STAFF RECOMMENDATION

1500 Holly Street

Application: New Construction – Infill

Description of Project: Application for the new construction of infill and a detached outbuilding.

Figure 3. Streetscape. Dotted line shows prior version, applicant has reduced the height to better meet the context. 1504 Holly was destroyed by the tornado, but is indicative of the historic streetscape.

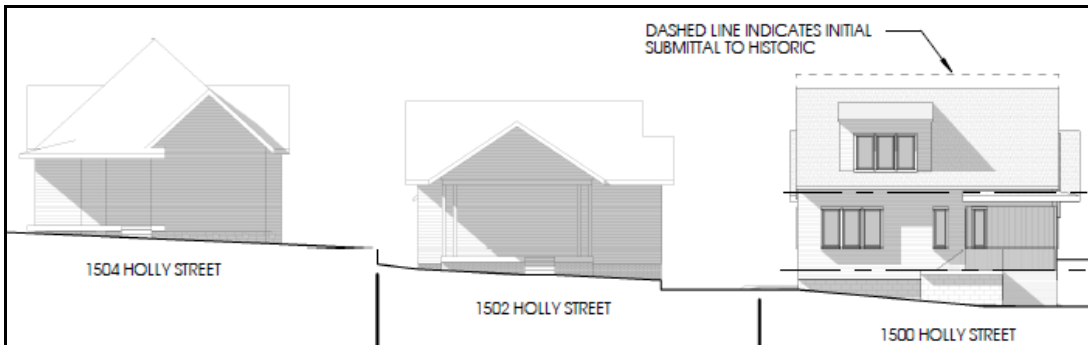
The two blocks of Holly Street impacted by this site have a significant slope across the street-frontage. Exact height measurements varying depending on where they are taken, but the historic houses in the immediate block face have heights ranging from about twenty-one to about twenty-eight feet (~21'~28'). The proposed infill sits on a particularly steep lot and measures about twenty-seven feet, six inches (~27'6") at the front, from average grade. The applicant has provided a streetscape showing the two houses uphill from the infill which shows how the massing will fit into the streetscape. See Figure 3.

Figure 4. Cross section of Holly Street with the infill on the left and the existing historic house it will face on the right.

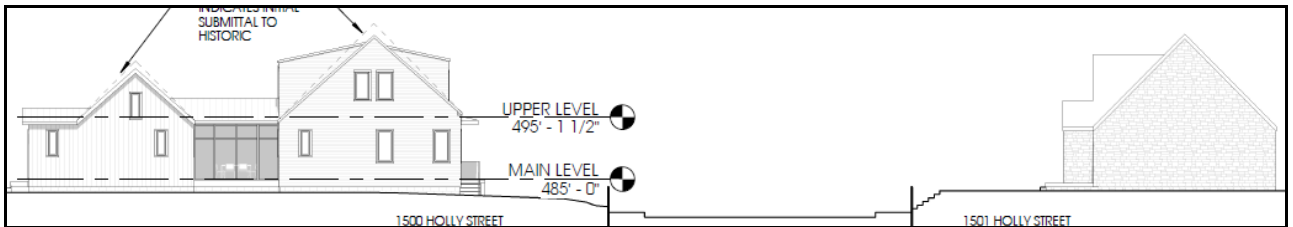
To further illustrate the impact on the context, the applicant provided a cross-section of Holly Street, showing how this house compares to the historic house immediately across the street at 1501 Holly. This is particularly valuable, as these two houses sit on similarly sloped lots, falling in grade quickly toward 15th Street. See Figure 4.

Staff finds that the proposed infill is appropriate and meets section V.A. for massing and scale.

Figure 6. Side elevation facing 15th Street

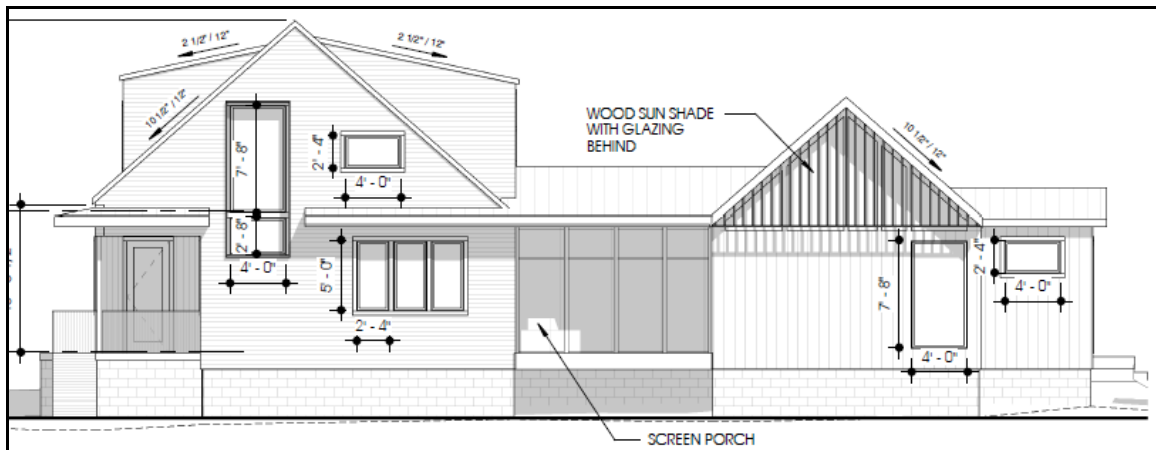
Proportion and Rhythm of Openings: There are no large expanses of wall space without a window or door opening. The windows are all generally twice as tall as they are wide, thereby meeting the historic proportions of openings. There are two horizontal windows which staff finds appropriate in this instance as they are accent windows and not the primary window form. Staff finds the project's proportion and rhythm of openings to meet Section V.D.

SITE PLAN

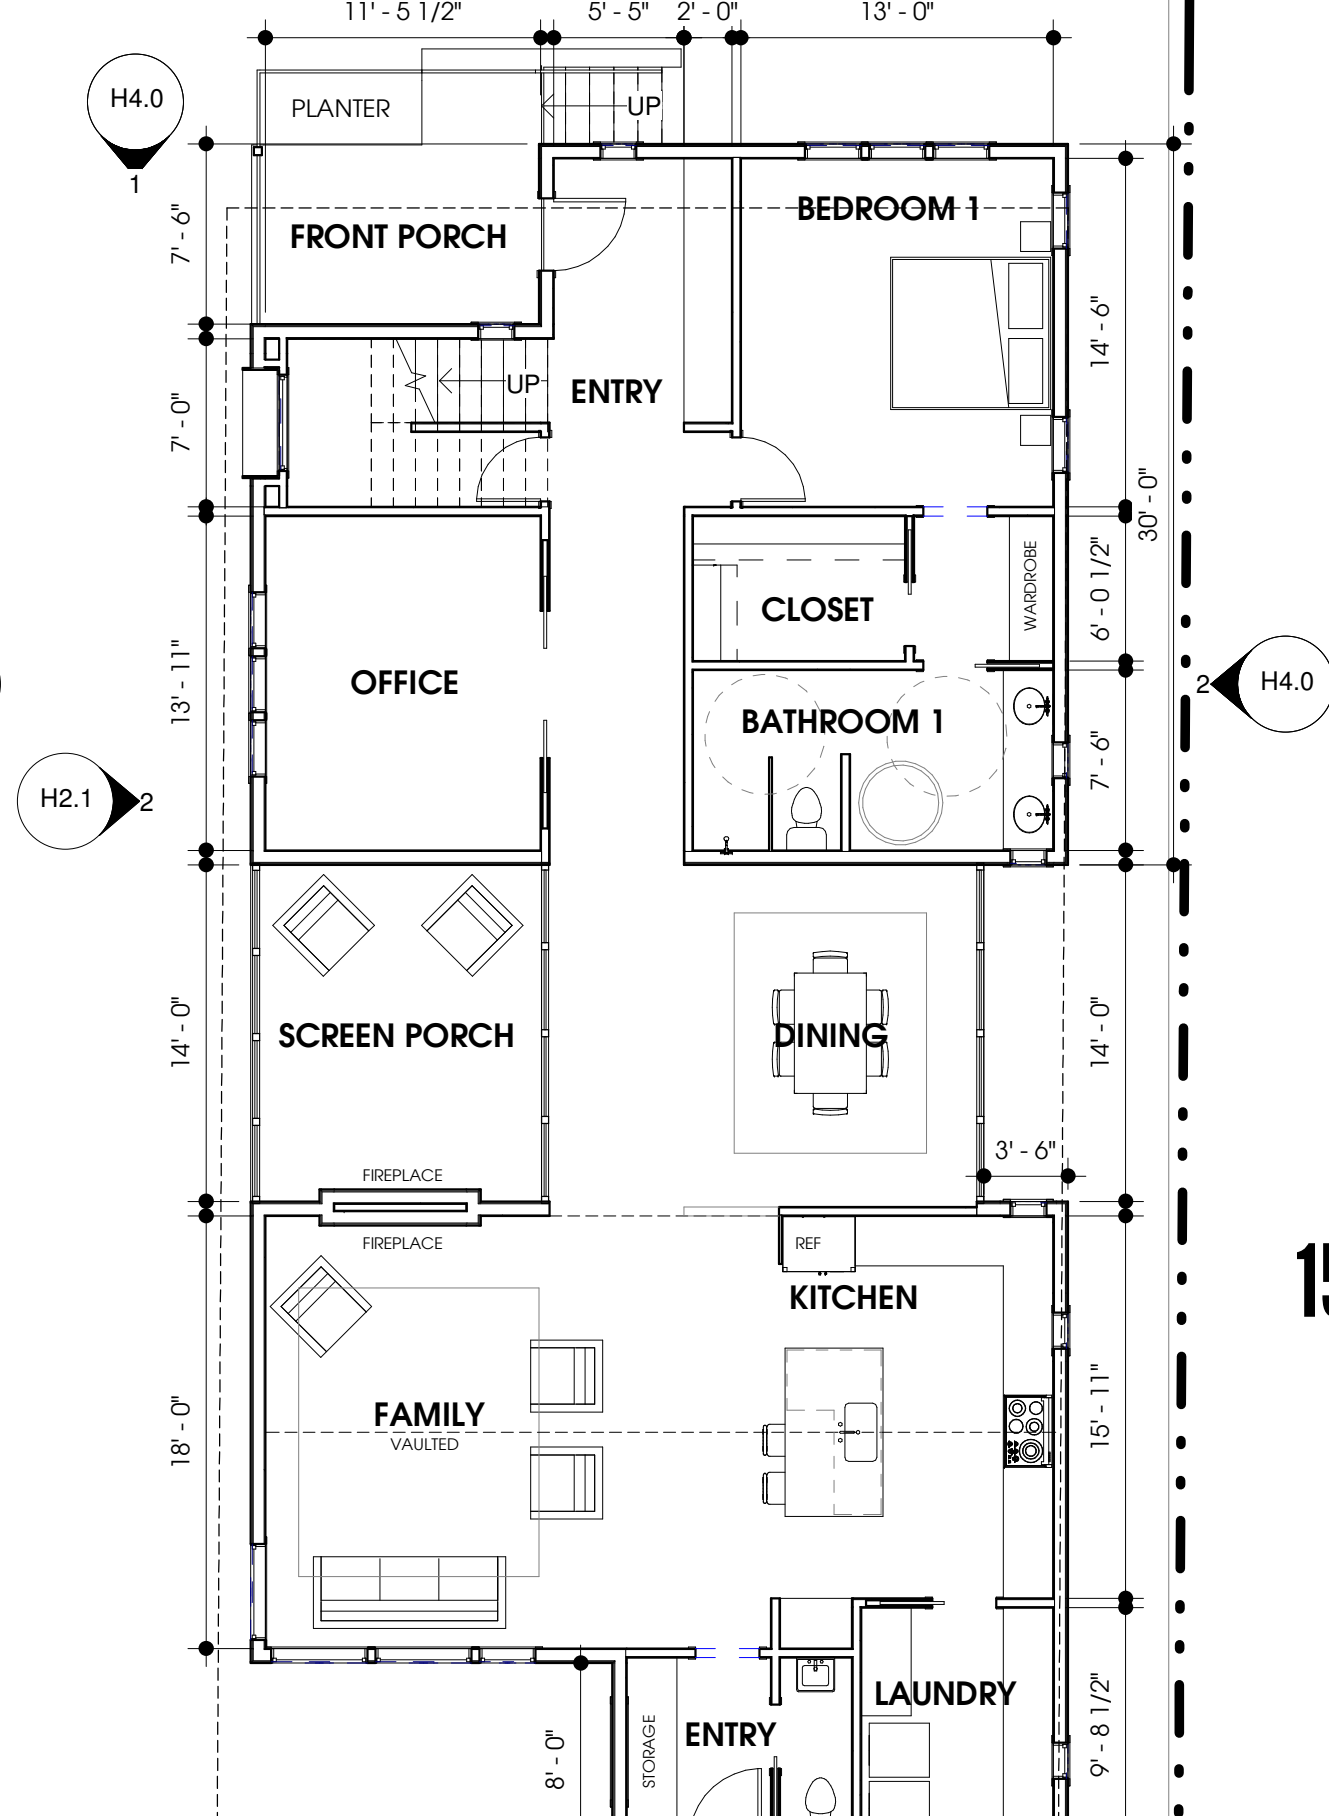
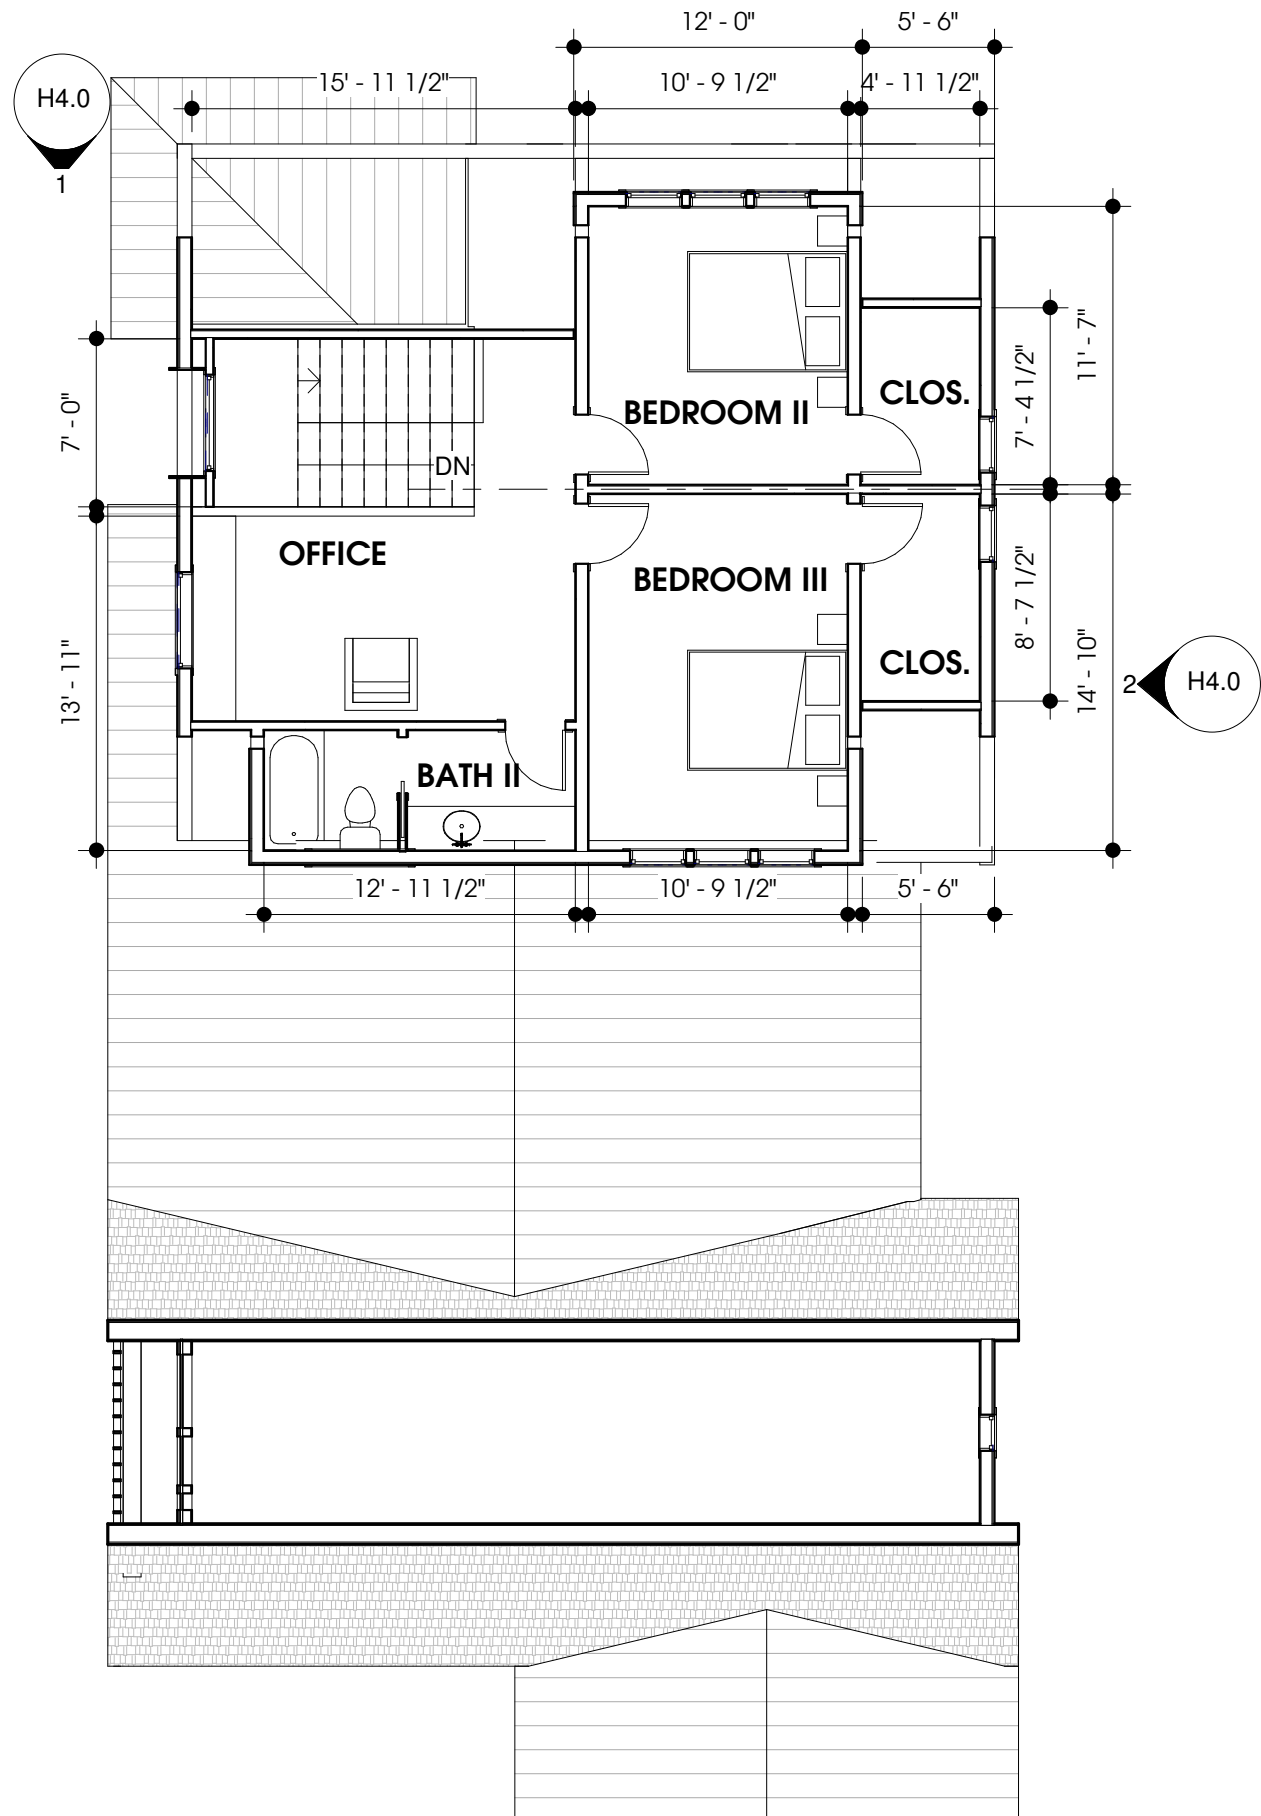
The infill is oriented toward Holly Street. The front door faces the side street, opening onto the partial width recessed front porch. This is a common historic configuration and is appropriate to this context. The site plan indicates a walkway from the front door to the sidewalk. The site plan also indicates a future outbuilding. While the outbuilding is not a part of this application, the site plan illustrates that there is sufficient space on the lot to site such a structure in the future and maintain all required setbacks, including the twenty-foot (20') distance between the house and the outbuilding.

ELEVATIONS

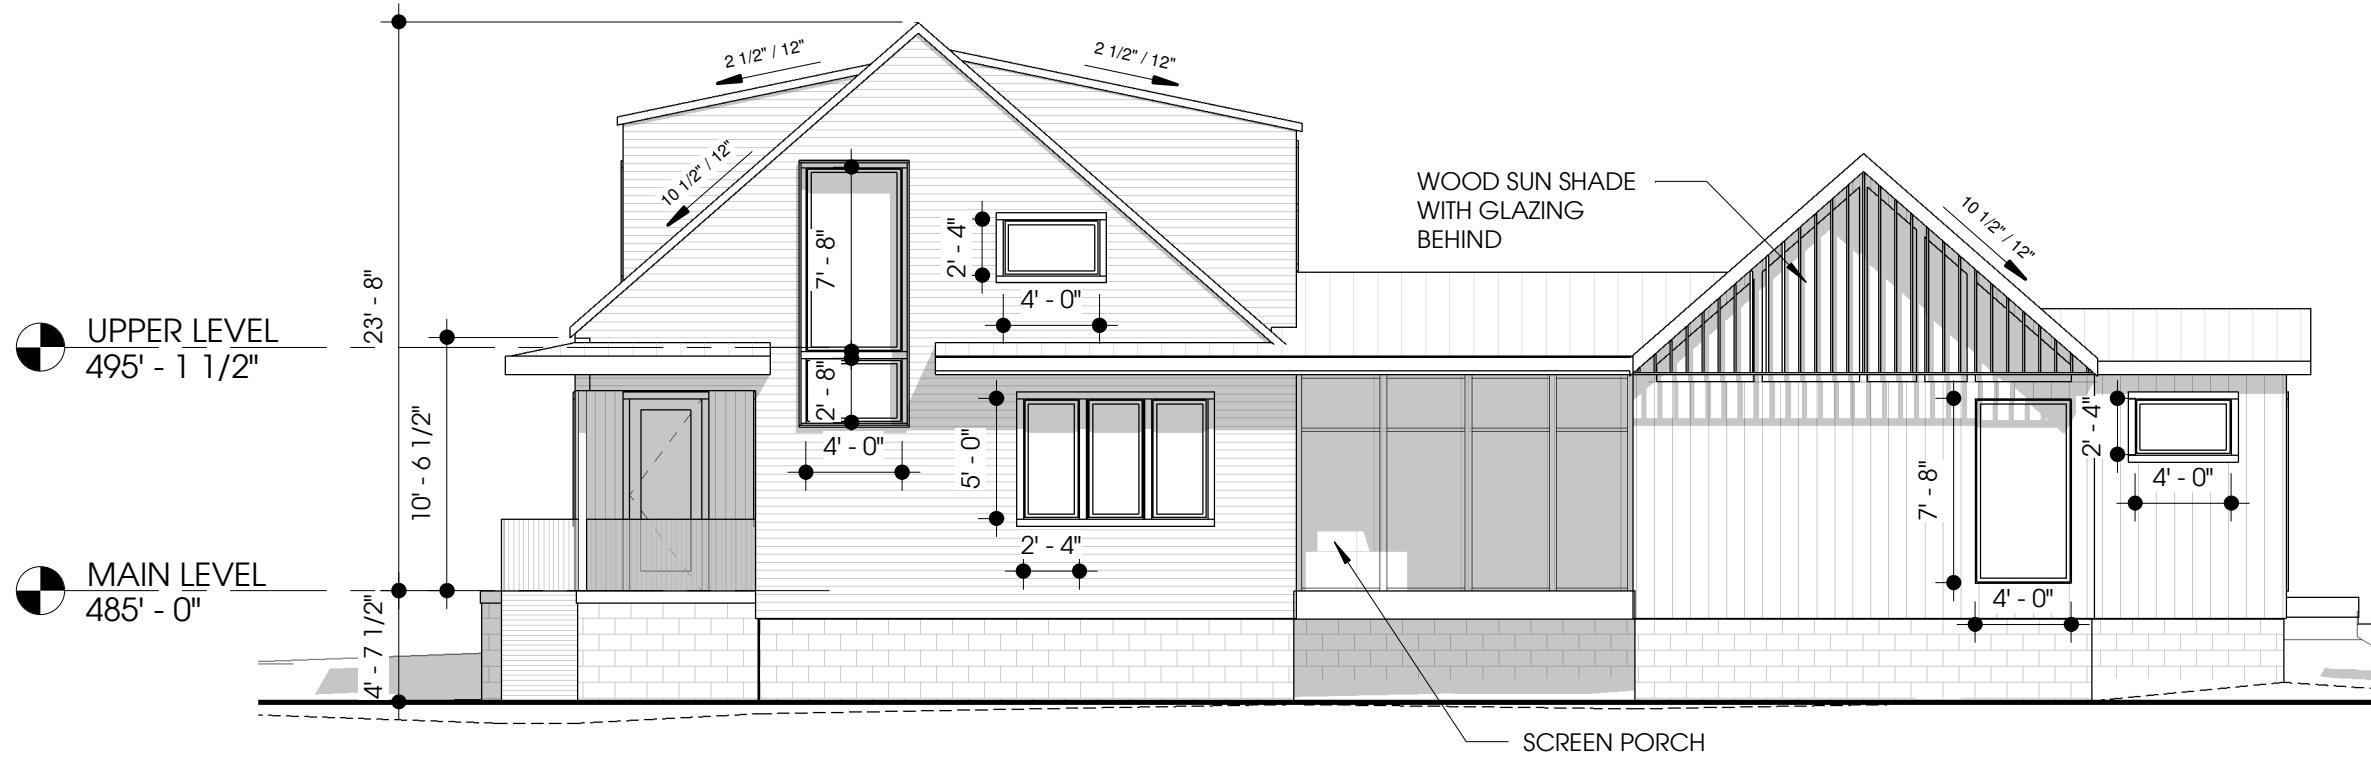
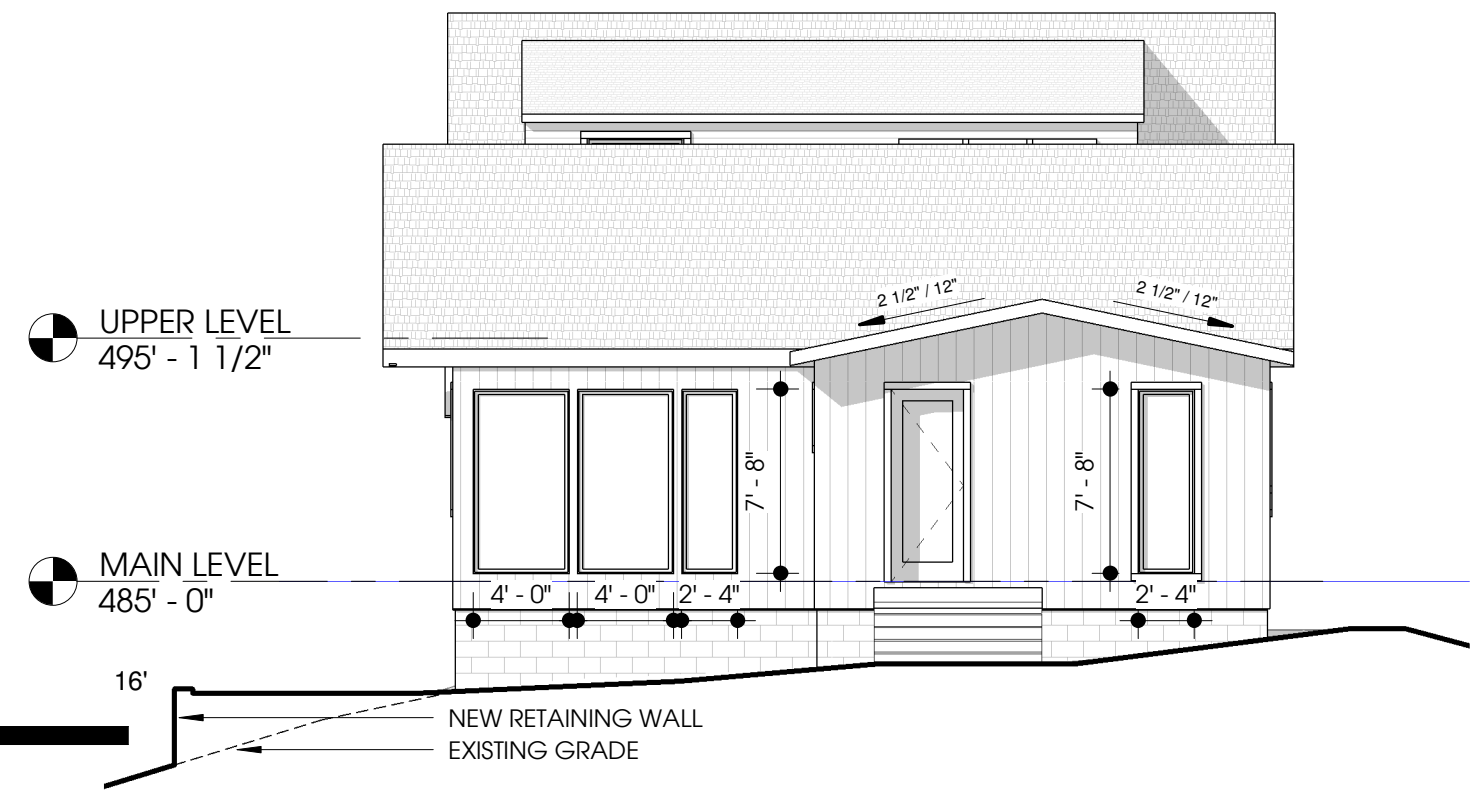
Four inch (4") corner boards are required at the face of each exposed corner. The porch post does not show a base or capital, which is typically required. Additionally, the west elevation shows windows filling the side gable field with a wooden sun shade applied. This is not a historic feature, but staff finds it appropriate to the modern design of this structure.

With the inclusion of corner boards, the addition of a base and capital to the porch column and final staff review and approval of the siding, the metal roofing, the trim

material, the porch floor and steps, the porch post and railing, the rear steps, the walkway material and all doors and windows, staff finds that the project meets section IV for materials.
